SIB 66 13 23

CAMERA-BASED ADAS: CCM FOR RESTRICTED FUNCTION – KAFAS CAMERA HOOD DEFORMATION

2025-12-17

This Service Information bulletin (Revision 2) supersedes SI B66 13 23 dated October 29, 2025.

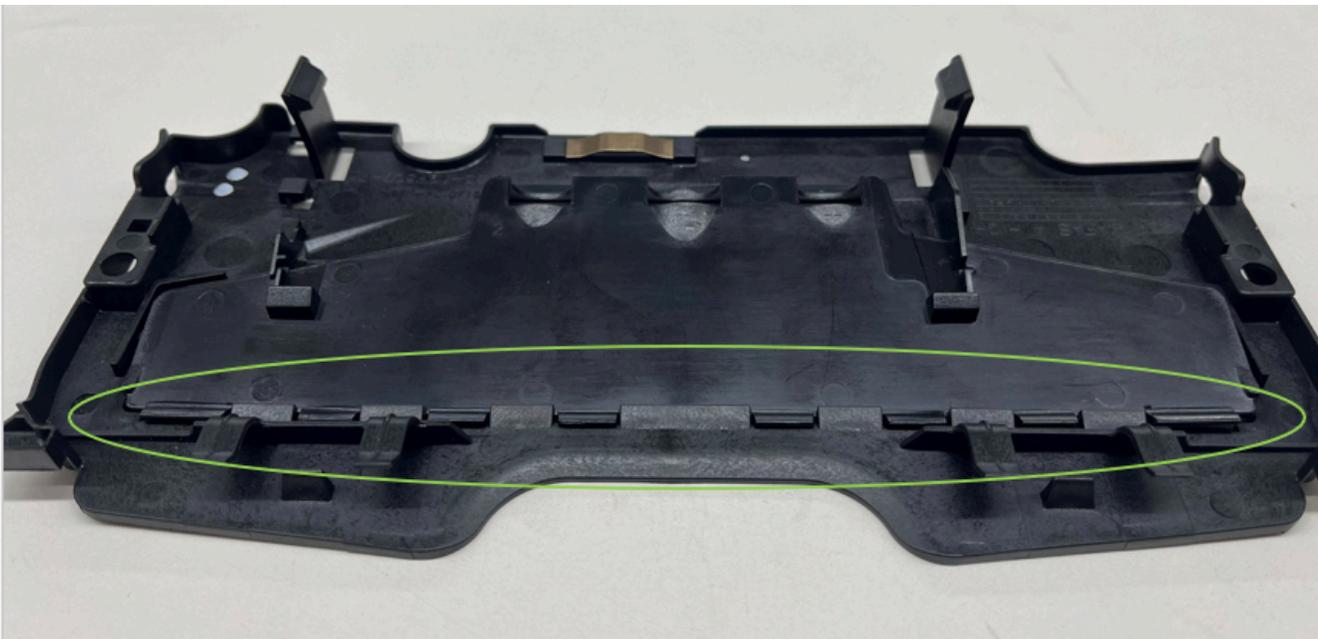
2. When installed, check whether the KAFAS hood is in contact with the holder/mount all the way around. See example photos below. **Red** highlighted showing distortion. **Green** highlighted showing no defect.

If you find distortion, replace the KAFAS camera hood with part number 51 31 5A93179 for (F97 G01) front windscreen trim or part number 51 31 5A9A552 for (F98 G02). Then follow the below modification steps.

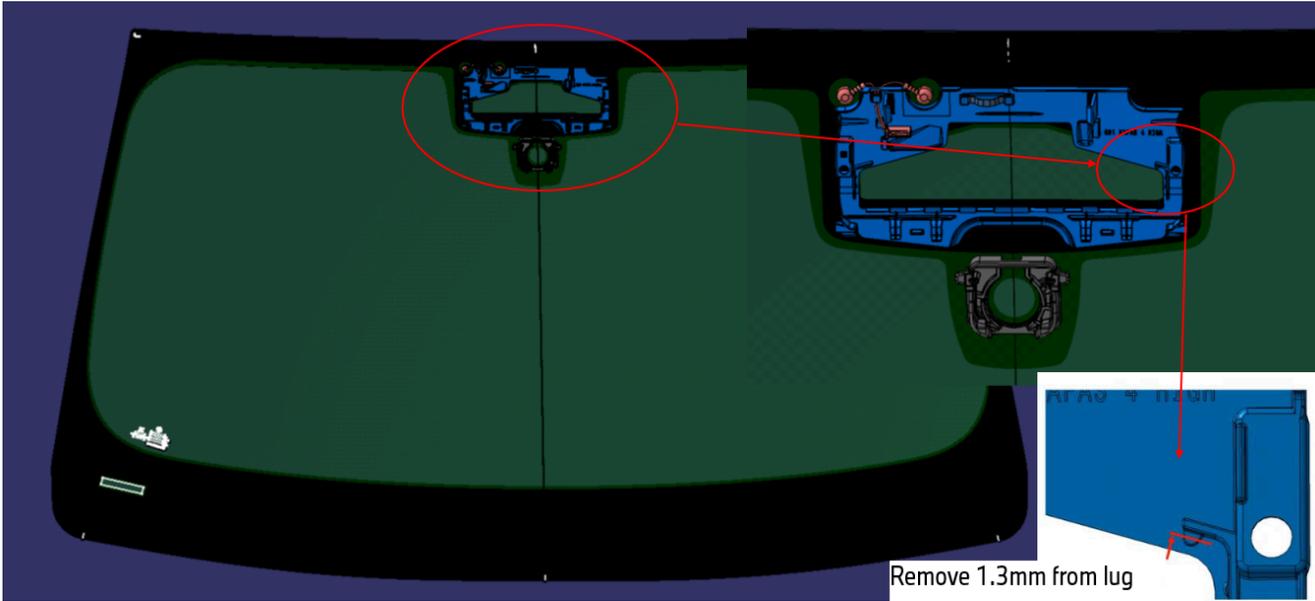
3. Remove the interior mirror trim, the interior mirror, the KAFAS camera and the KAFAS camera hood so that access to the retaining lug shown at the bottom right of the example photo is ensured.

The mounting point for the KAFAS camera hood must be adjusted.

Using a grinding tool (for example Dremel®), shorten the entire surface of the retaining lug by 1.3 mm. See example photo with location for modification. Then deburr and clean it thoroughly, and remove the adhesive tape.
